# **2014 - 2015 Corvette: Service Bulletin: Creak or Snap Noise Above Windshield from Removable Roof Lift Off Panel While Driving**

**GM Bulletin No.:** #15-NA-016

**Date:** September 30, 2015

**MODELS:** 2014 - 2015 Chevrolet Corvette

(1) Example of a bad front locating pin.  
 (2) Example of a good front locating pin.

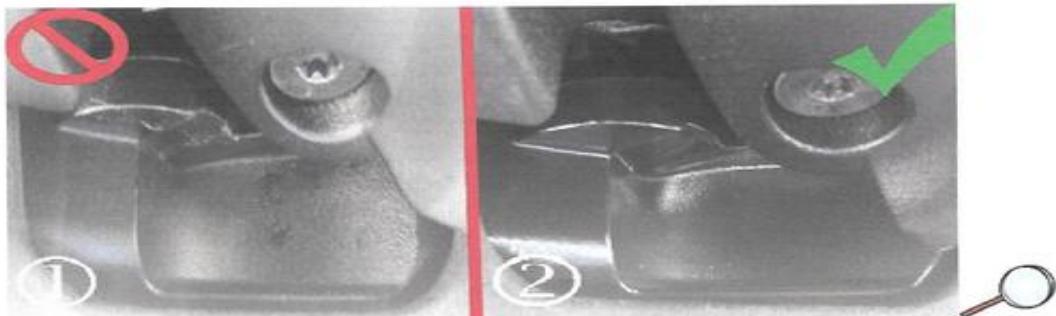
**CAUSE:** This may be caused by a stick-slip condition between the front latches against the strikers and the front locating pins to the locating cup in the strikers.

If you encounter a vehicle with the above concern, replace both the front roof lift off panel strikers and both front locating pins. Refer to Roof Lift Off Panel/Window Front Striker Replacement and Removable Top Locating Pin Replacement in SI.
